LES SCHWAB TIRE CENTER 7105 N. MERIDIAN ROAD FALCON, COLORADO 80831 SITE DEVELOPMENT PLAN

1	4/6/18	SDP SUBMITTAL
2	6/8/18	2ND SDP SUBMITTAL
		<u> </u>
_		
_		
_		
_		
_		
_		
_		
_

SITE PLAN

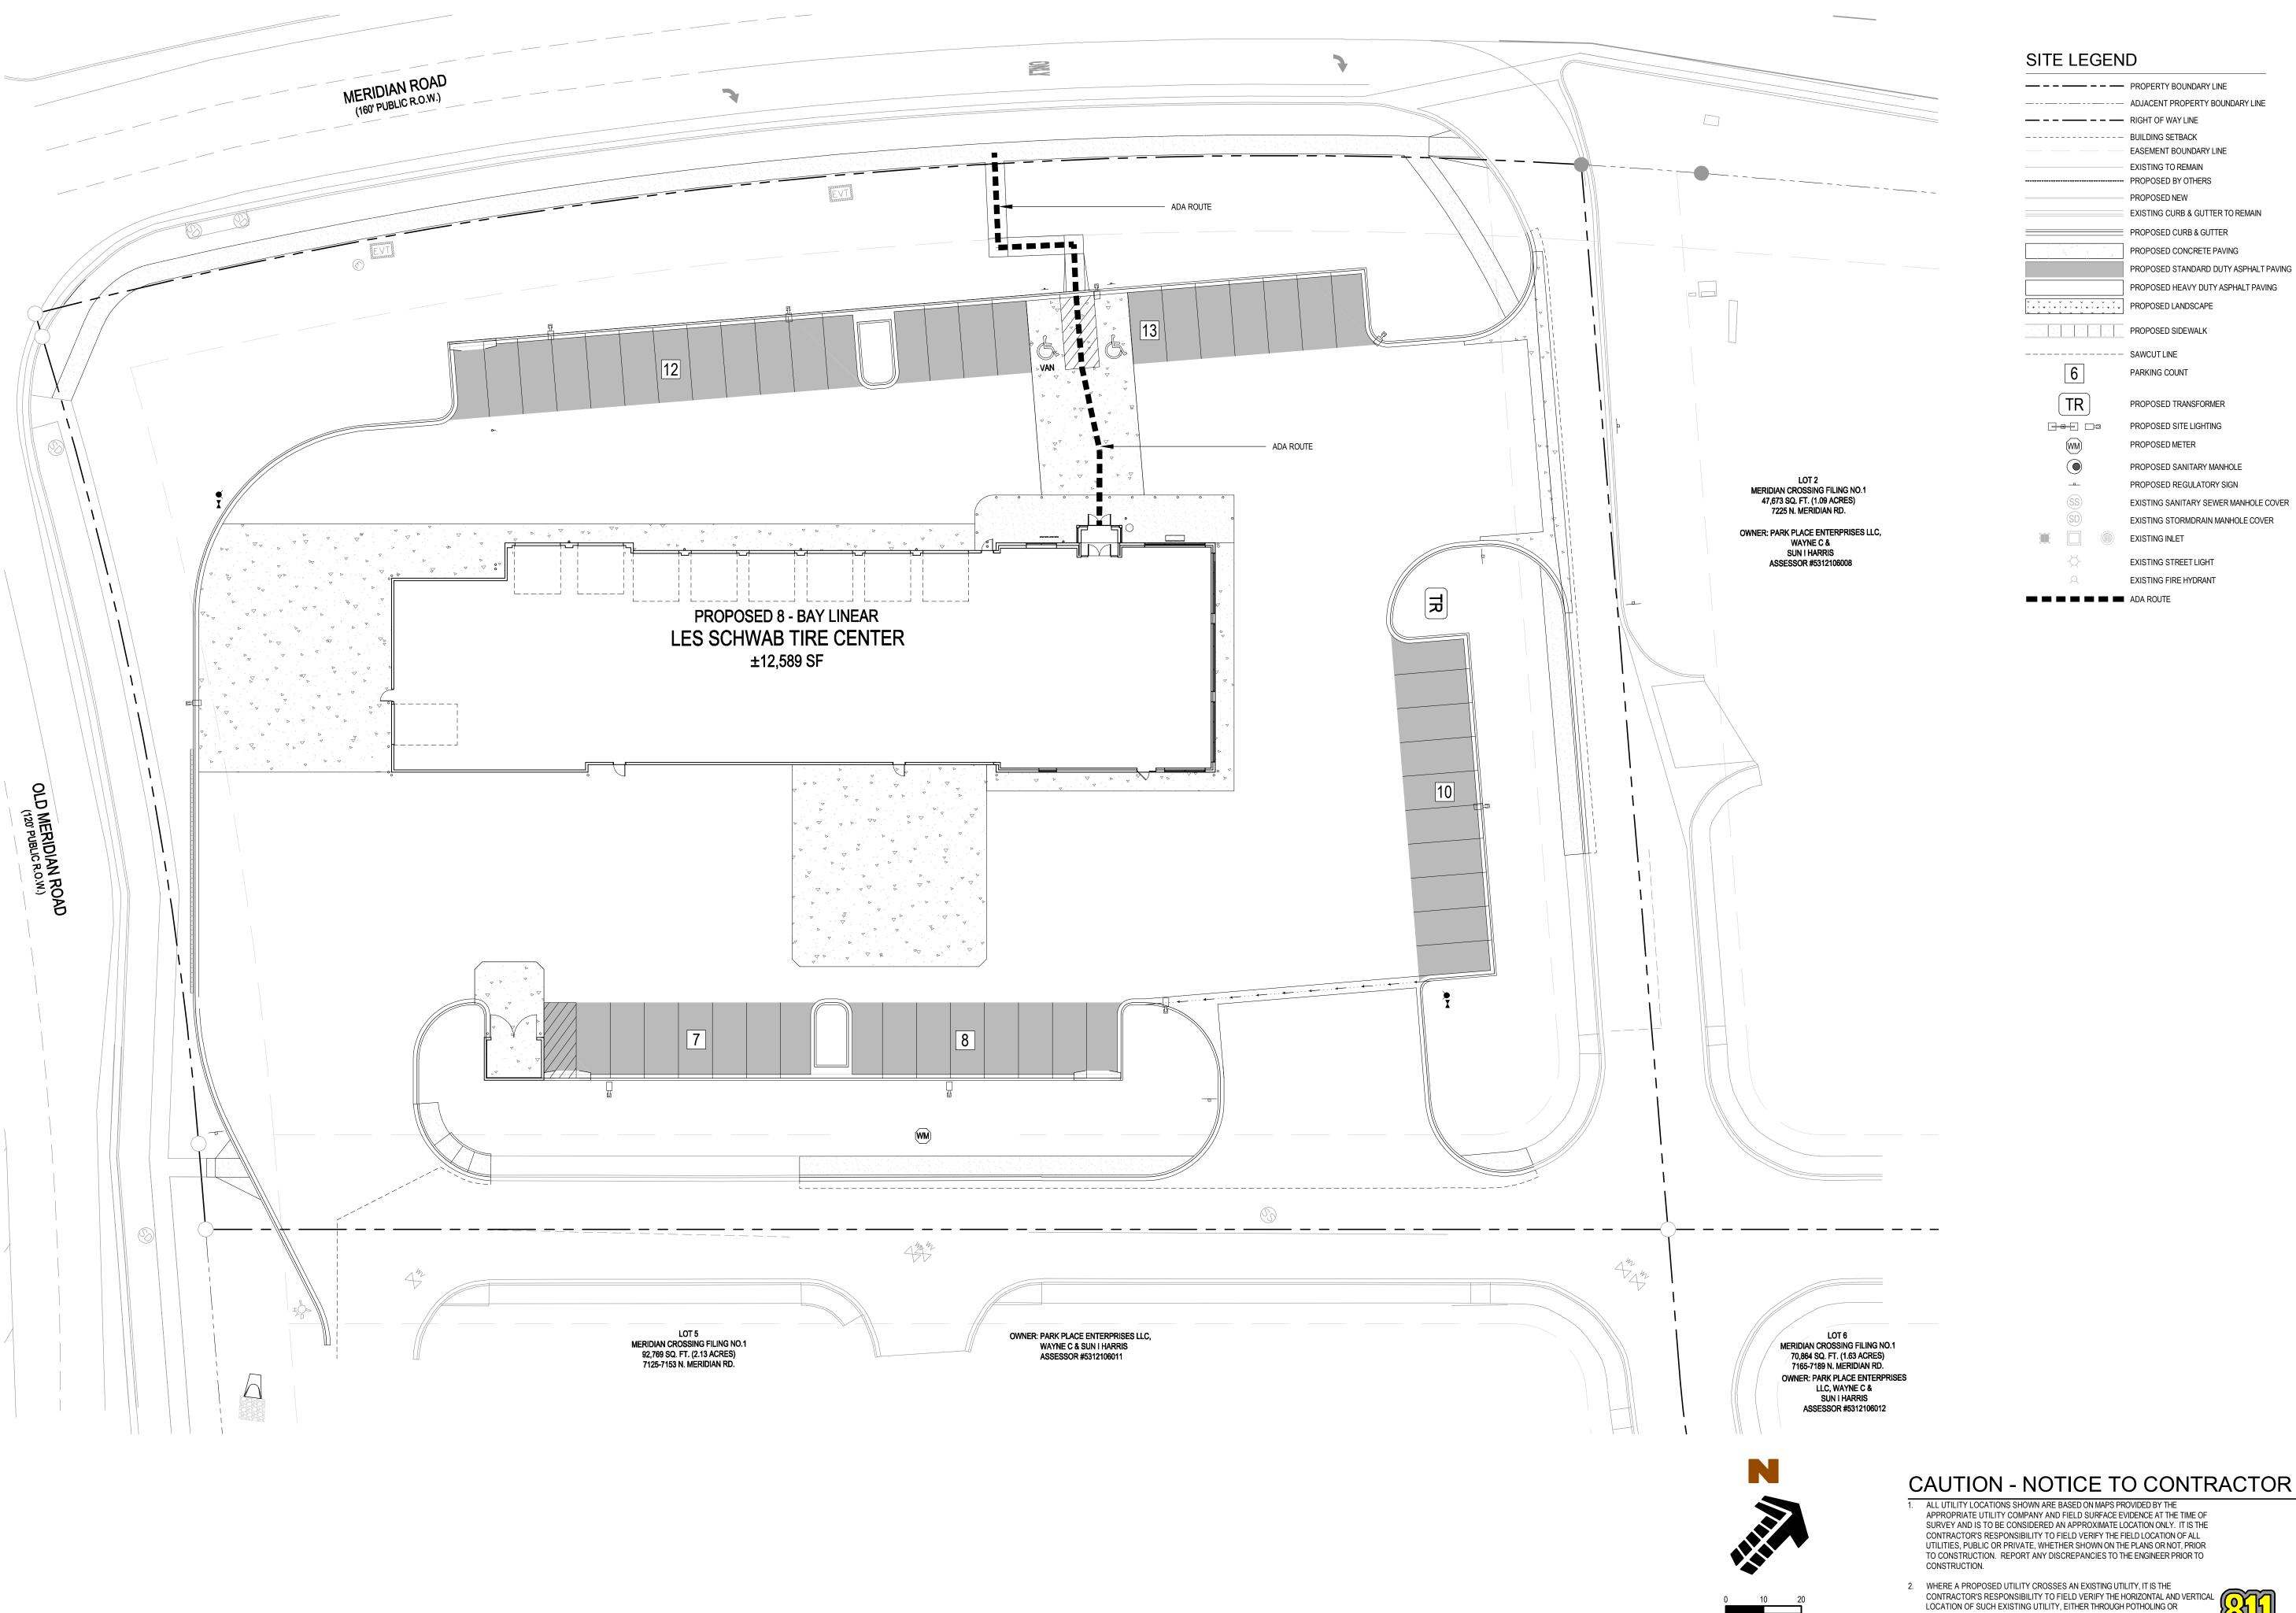
all location where sidewalks cross a road will be required to provide ADA accessible pedestrian ramps.

the site development plan should show all proposed work.

LANDSCAPE PLAN

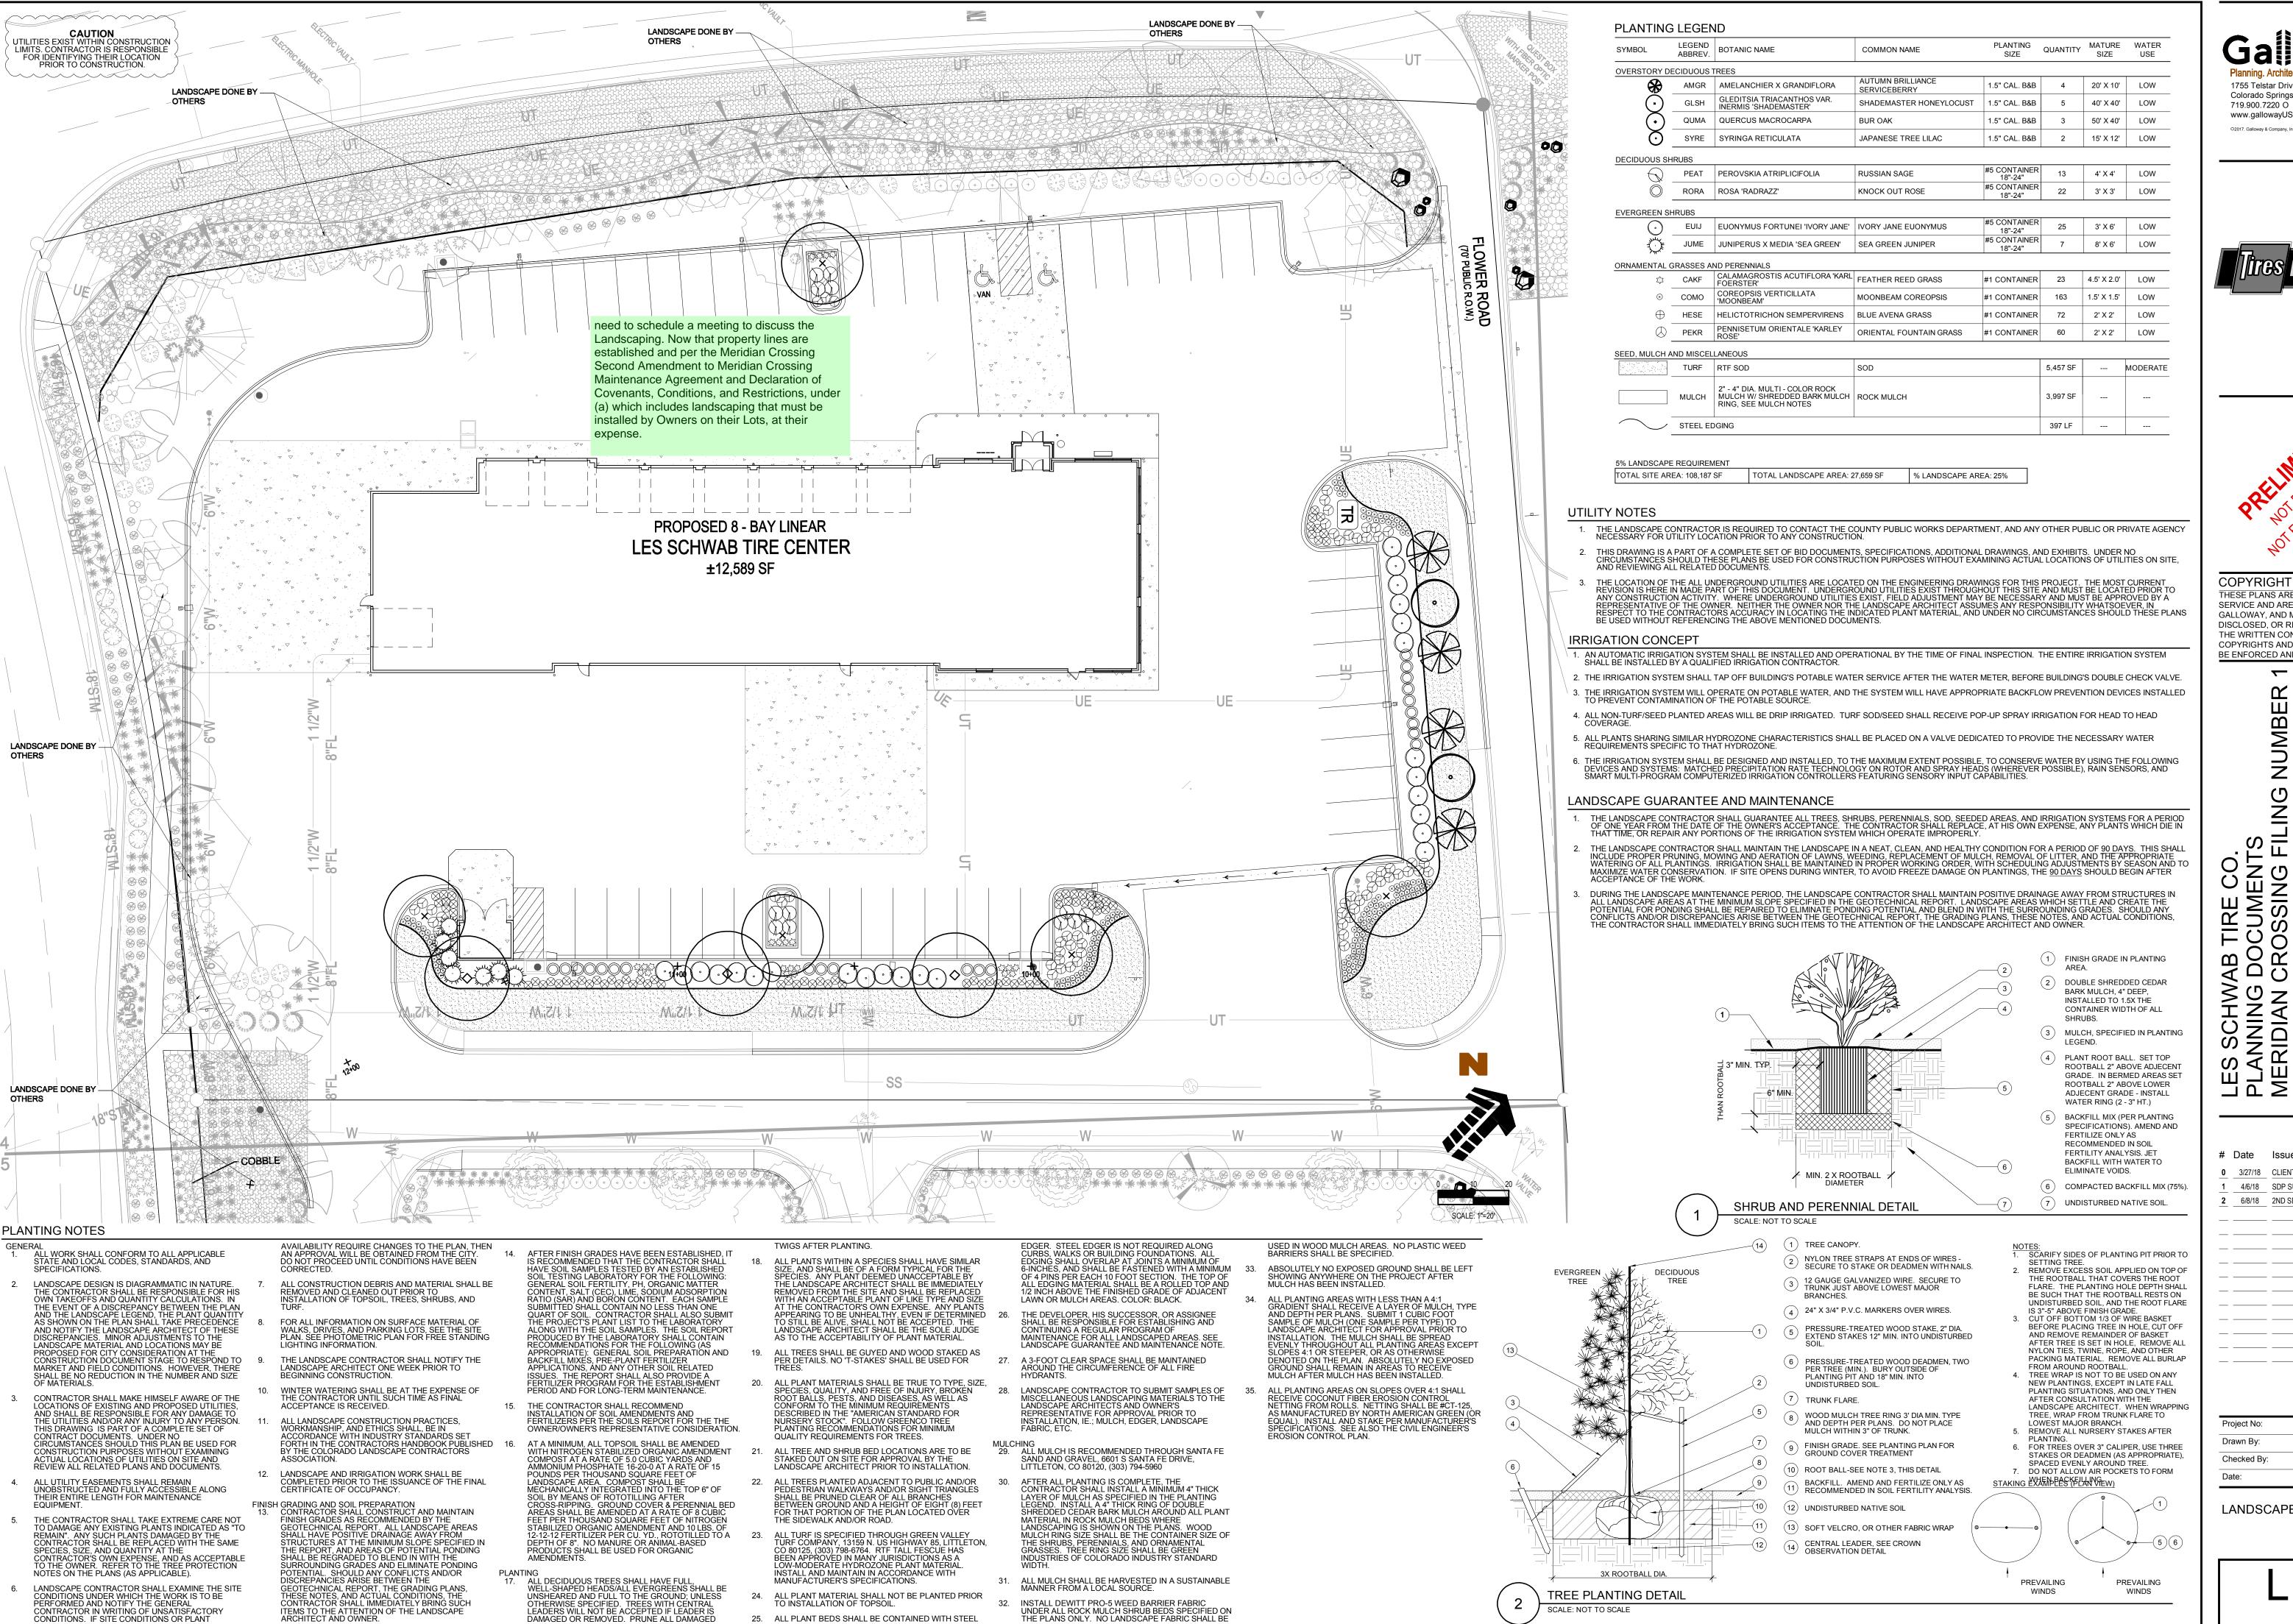
need to schedule a meeting to discuss the Landscaping. Now that property lines are established and per the Meridian Crossing Second Amendment to Meridian Crossing Maintenance Agreement and Declaration of Covenants, Conditions, and Restrictions, under (a) which includes landscaping that must be installed by Owners on their Lots, at their expense.
